Plan Commission

Monday, June 24, 2019

SUBJECT: Staff recommendation and possible action regarding a Precise Implementation Plan (PIP) for 1881 Southbridge Road (Parcels WD-1831 through WD-1838). Submitted by Brandon Robaidek, EIT, authorized representative for Crosspoint Church INC ETAL, property owner.*

PRECISE IMPLEMENTATION PLAN – 1855 - 1881 SOUTHBRIDGE ROAD

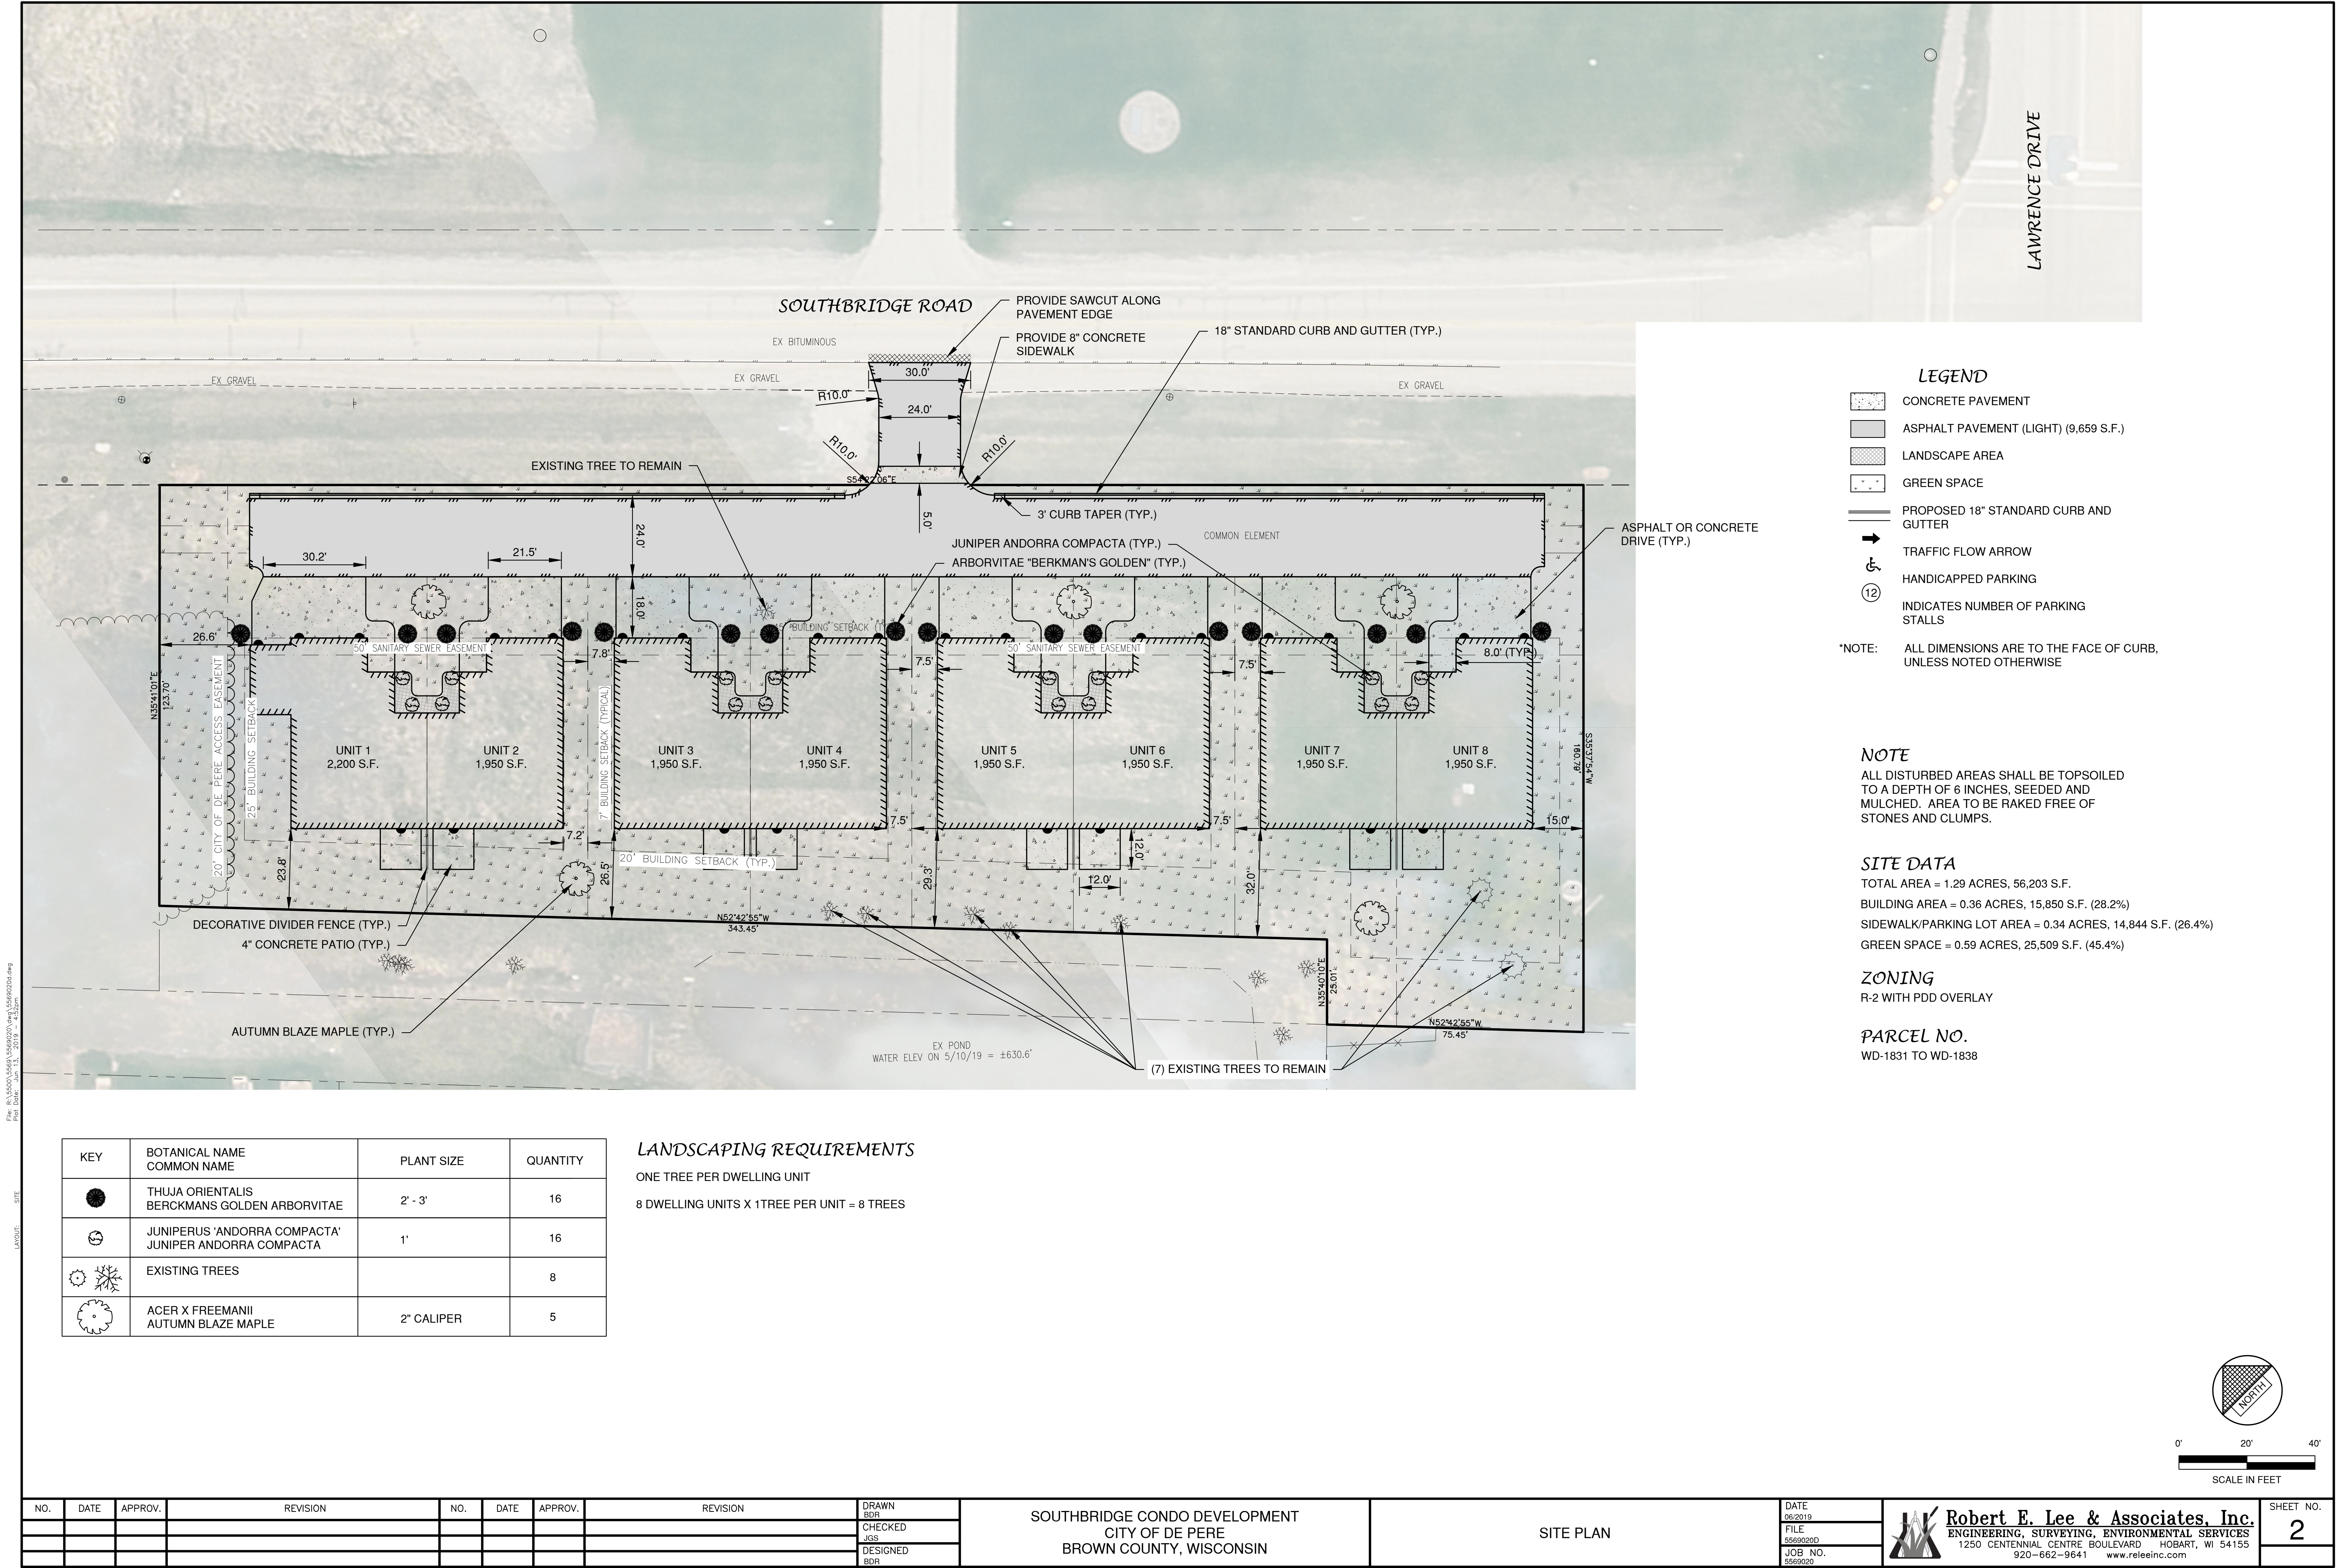
5. Sheet 1: Label 12-foot utility easement along the right-of-way line.
6. Sheet 2: 8-inch sidewalk should not have a radius. Square off the sidewalk for ease of future construction.

7. Sheet 2: Identify the amount of pavement being saw cut on Southbridge Road. Due to the age of the roadway surface, excessive cutting may result in the pavement being replaced to the centerline.

8. Sheet 2: Label 12-foot utility easement along the right-of-way line.
9. Sheet 2: Buildings are shown to be constructed within the 50-foot sanitary sewer easement. This is not permitted without further action. Consider narrowing or releasing the easement to eliminate the concern.

File: R:\35000\55690\55690200.dwg Plot Date: Jun 10, 2019 6:10am LAYOUT: UTILITY

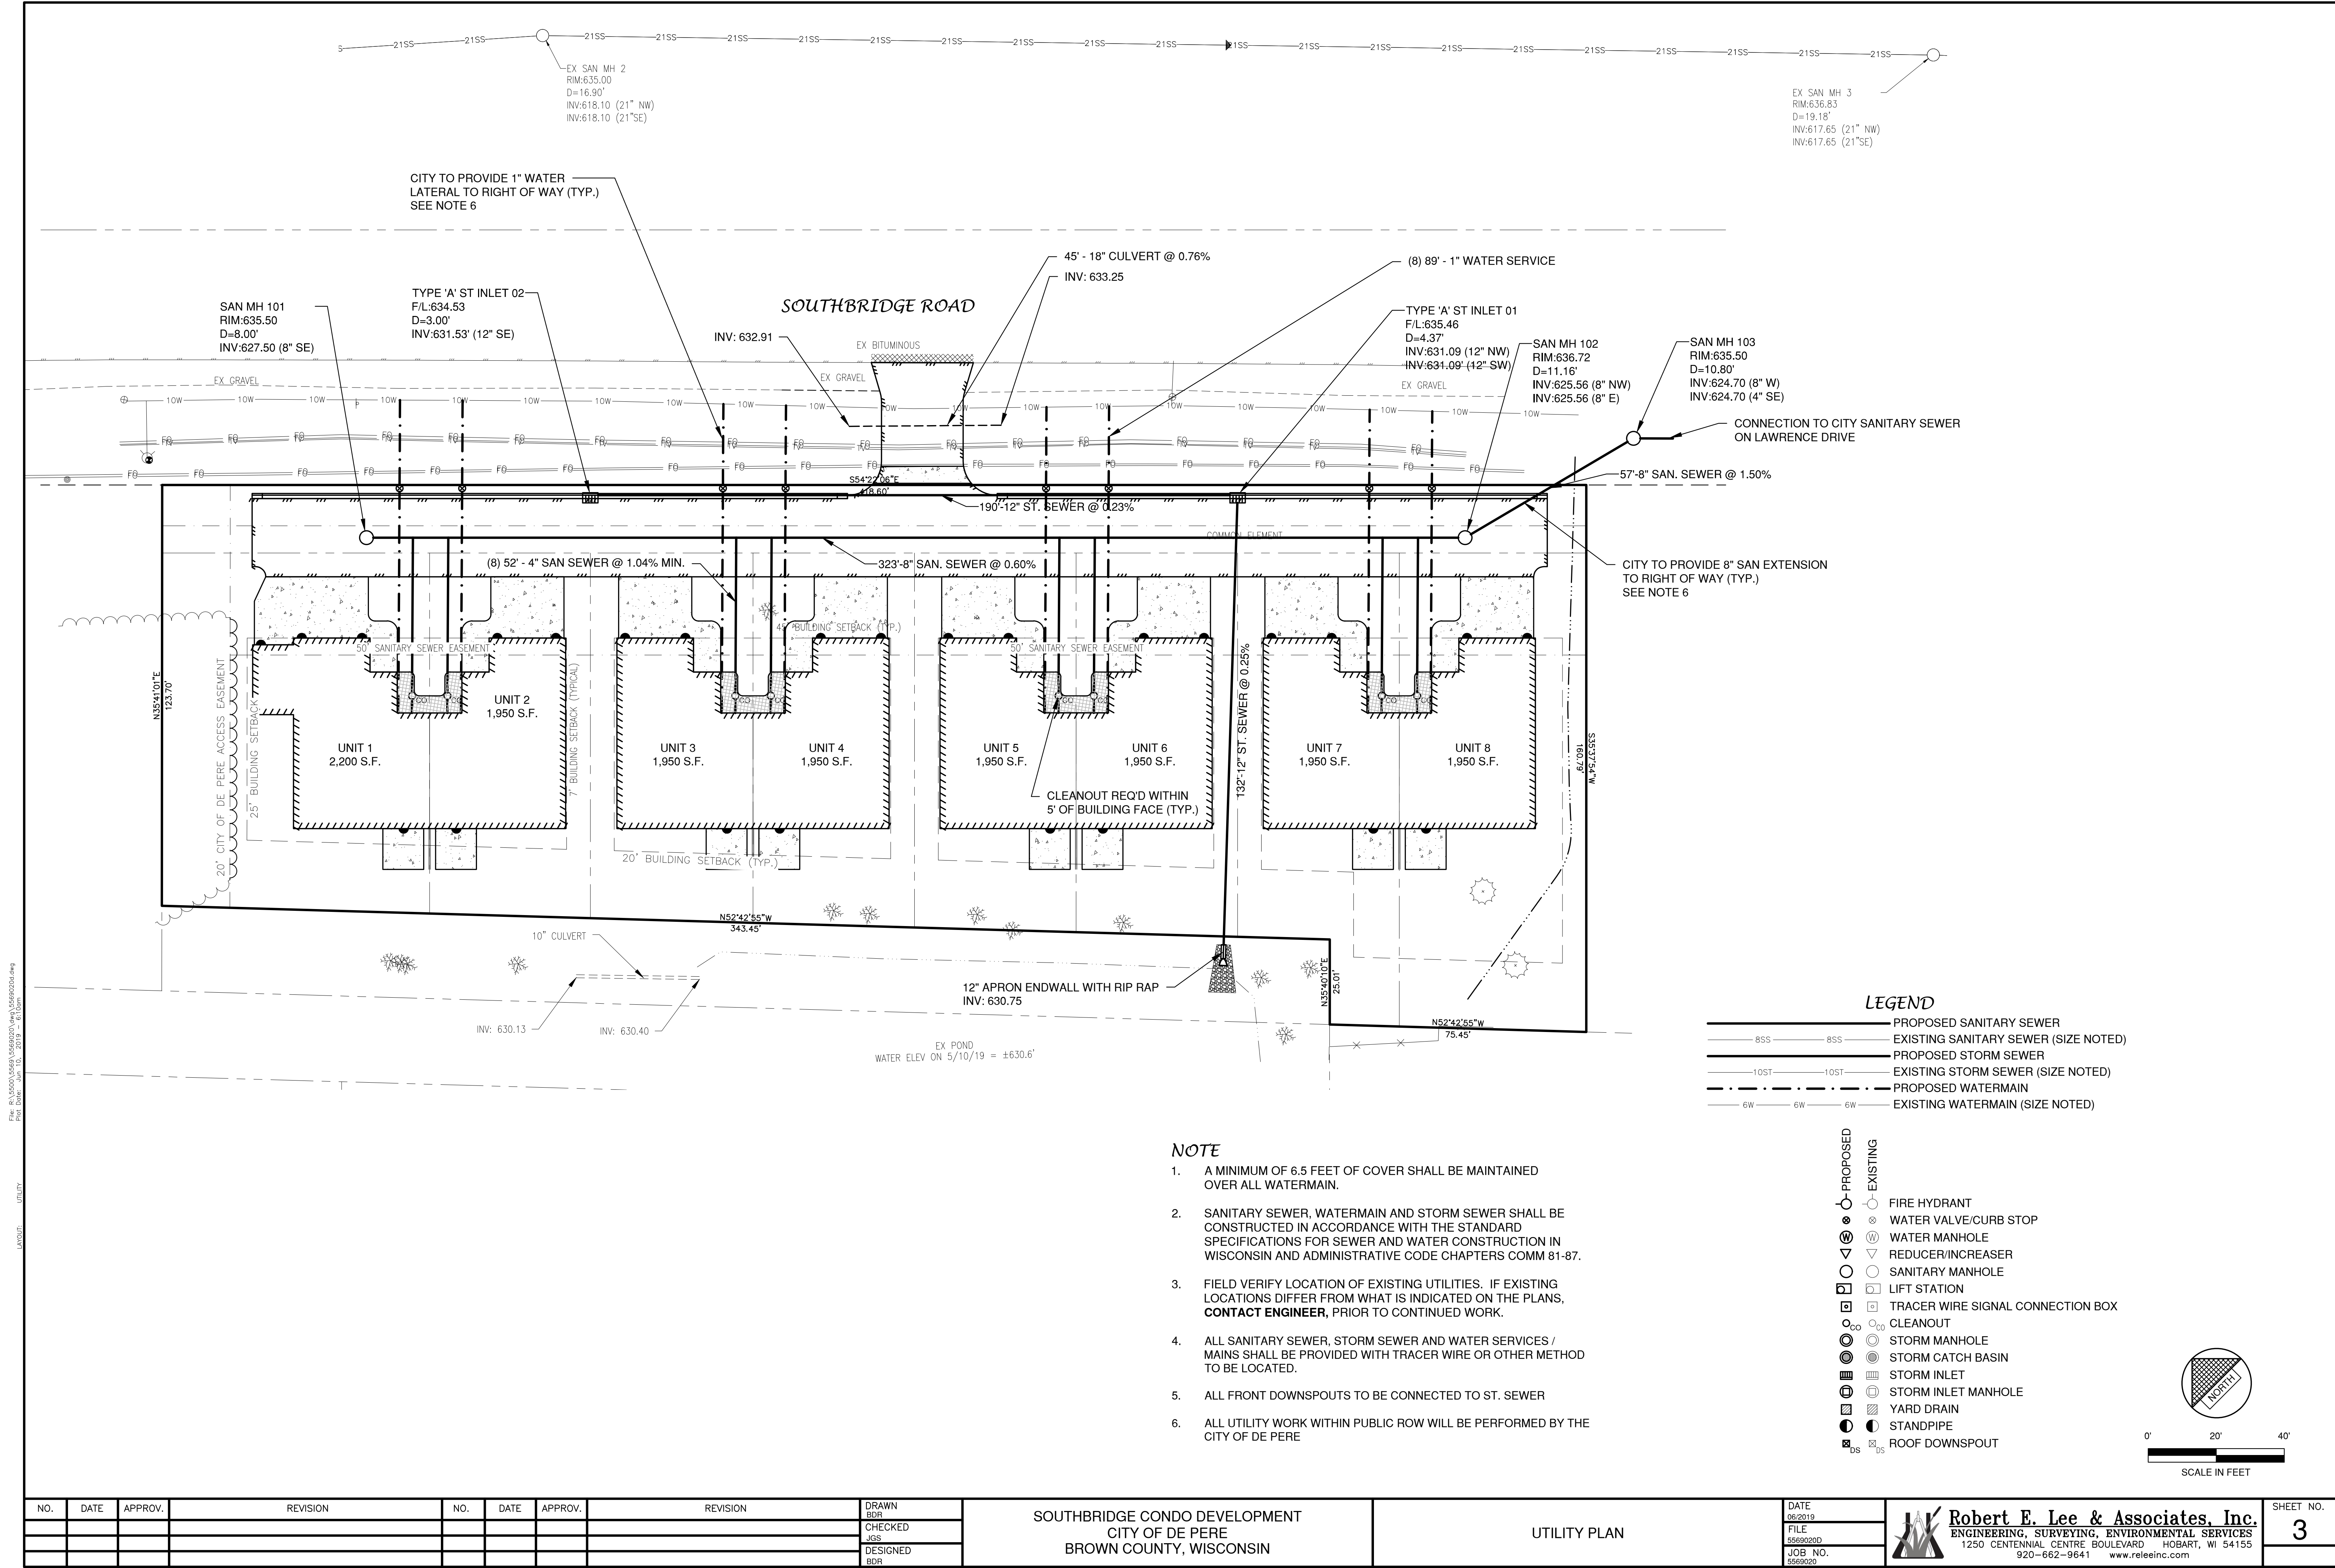
10. Sheet 3: Construction of new sanitary sewer to service this development will be subject to WisDNR Sanitary Sewer Permitting and NEW Water Sanitary Sewer Connection Permit. Permit approval will be required to City construction start. City will submit all permits for approval.

11. Sheet 3: City previously misspoke with regard to sanitary sewer alignment. Sanitary sewer will be tapped into ex. San MH 2 and will come directly south onto

12. Sheet 3: No gas or electric is located. Provide information on plans.
13. Sheet 3: Deciduous tree in front of unit 4 will most likely be lost as part of lateral construction. Call out to be removed. Replace elsewhere.

14. Sheet 3: Culvert under the driveway will need end walls and rip rap w/ geotextile fabric. Culvert at pond will need geotextile fabric as well.
15. Sheet 5: Identify where ditch checks or erosion mat are being used. Is sheet 10 needed? Stockpiling locations should be called out on this plan with appropriate erosion control protection.

- a. Sheet 3: You may lower the apron end wall elevation another six inches to be a foot above the permanent pool elevation of the pond. This will allow for greater slopes on storm sewer pipes throughout the site.
